# City of Alexandria, Virginia

## MEMORANDUM

SUBJECT: CONTINUANCE OF BAR#2025-00370 | CERTIFICATE OF  
APPROPRIATENESS FOR ALTERATIONS AT 301 KING ST. and 108 N.  
FAIRFAX ST.

*Option 4A, South Façade Rendering*

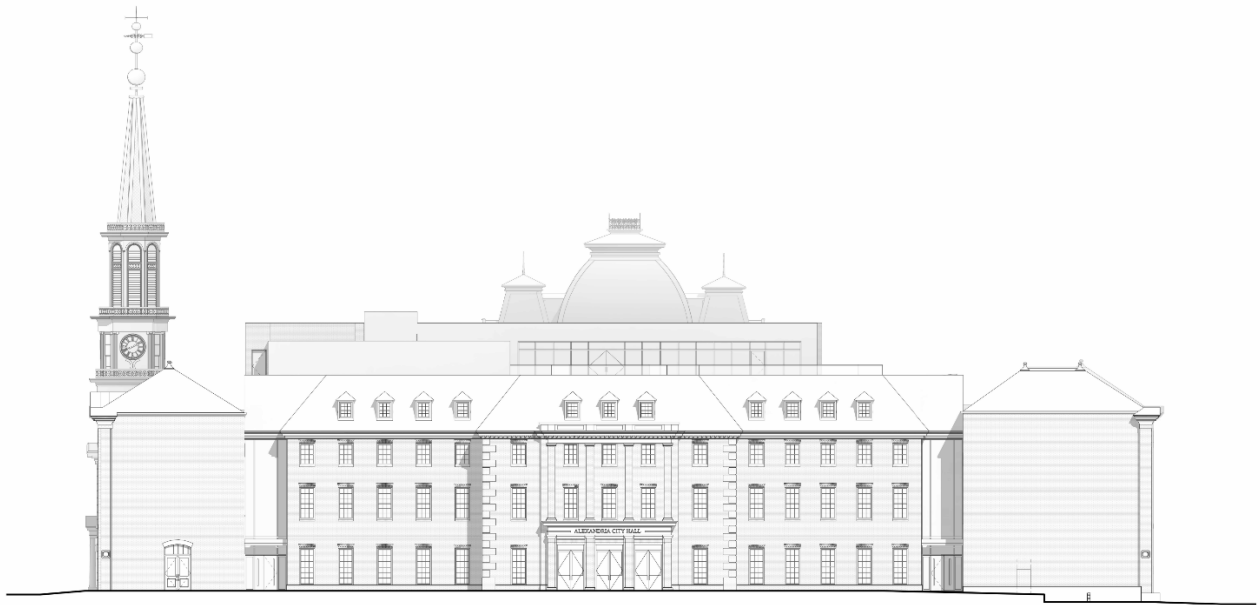
1. **MARKET SQUARE STRUCTURES:** Work with staff on the final design and detailing of the canopies, elevator enclosure, and seating steps to be consistent with the submitted renderings.
2. **5<sup>TH</sup> FLOOR:** Work with staff on the final design and detailing at the fifth-floor exterior so that it is similar in appearance to the adjacent slate roofs, and to ensure that glazing cannot be seen from the ground level.
3. **CENTER BAY:** Request to proceed with option 4A at the south façade, without chimneys, and with orthogonal brick-infill above the three vestibule entry doors. Work with the staff on the embellishment details for the ground floor entry doors at the south façade.
